MEETING: REGULAR MEETING OF THE VILLAGE BOARD
DATE & TIME: Monday, December 16, 2024 at 7:00 PM
LOCATION: Germantown Village Hall Board Room
N112 W17001 Mequon Road

- C. 2025 Permit Fee Schedule-Inspection Services
- D. Filling Vacancy in the Office of District 4 Trustee
- E. Jeff Osgood, Agent for Kwik Trip, Inc., and Ben Venue Properties, Property Owner, N112W18741 Mequon Road (former PNC Bank). Kwik Trip Convenience Store Relocation from W188N10963 Maple Road. Rezoning from B-3 to B-5 and Conditional Use Permit (CUP) applications.

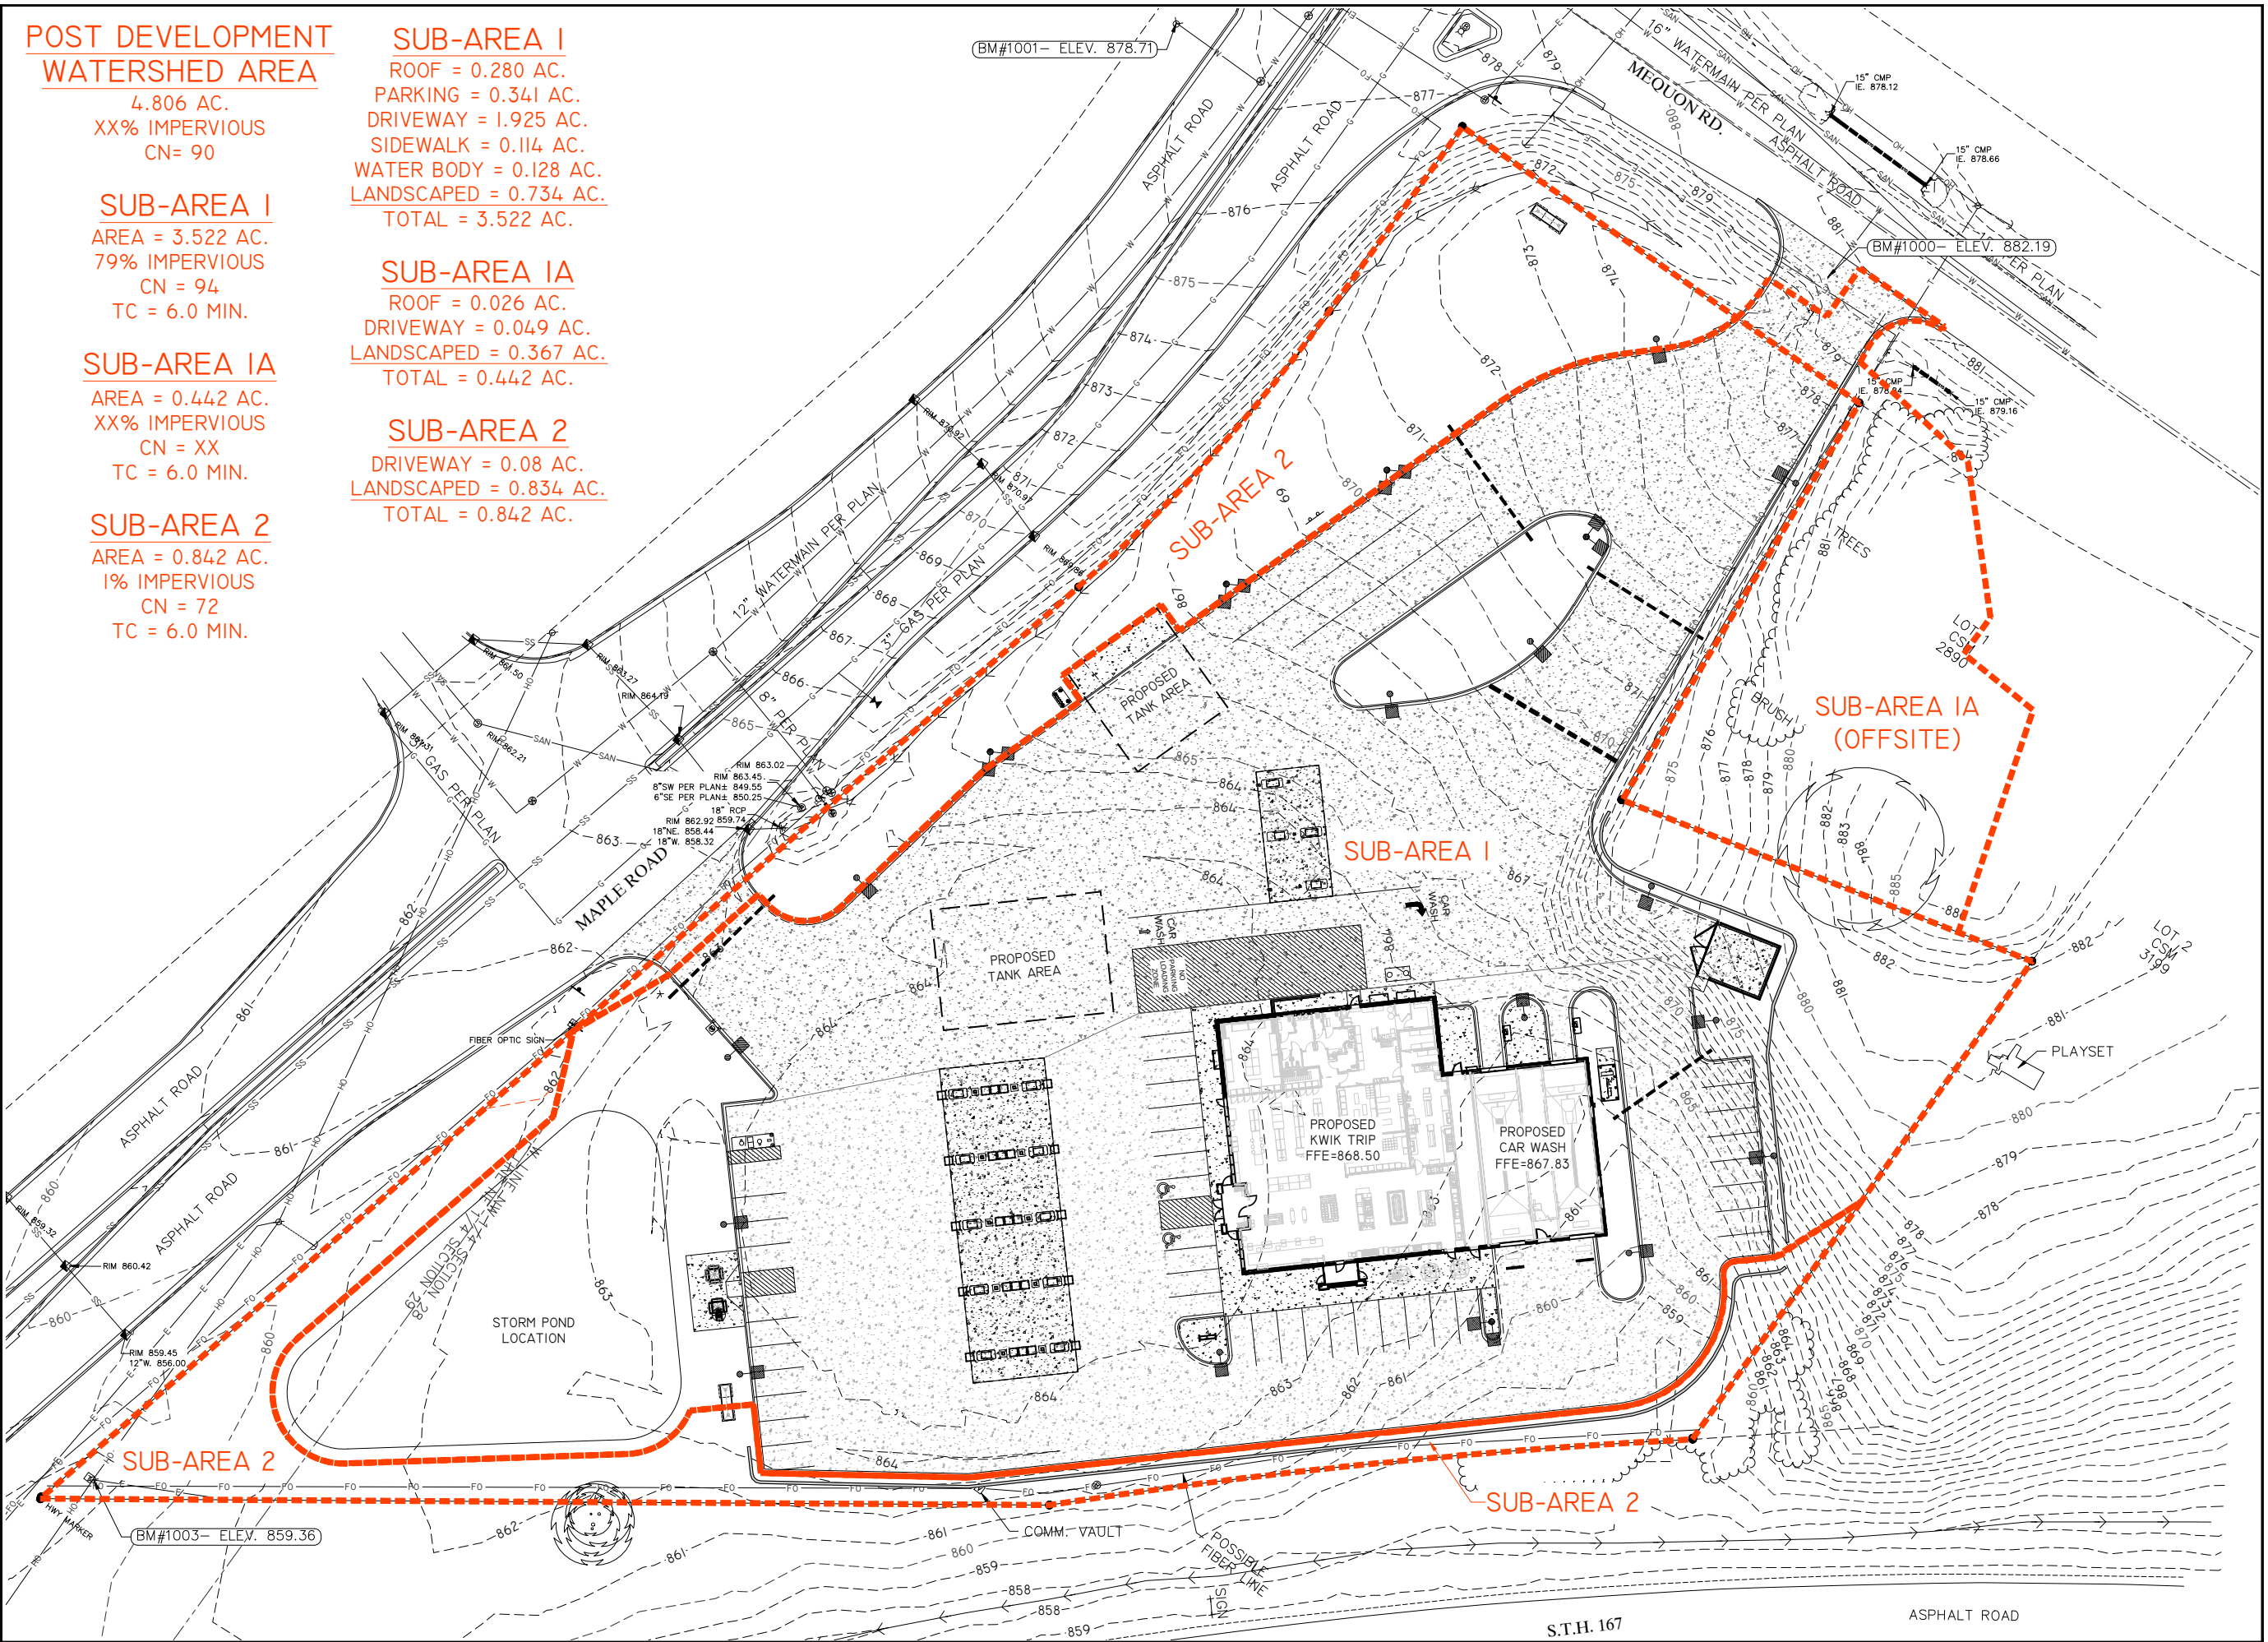
5. Show proposed grading on exhibit STM-1.
6. Show Tc paths on exhibit STM-1
7. Provide information on how the 100 year storm event will be routed to the basin. It appears some inlets will overflow offsite and not make it to the basin.
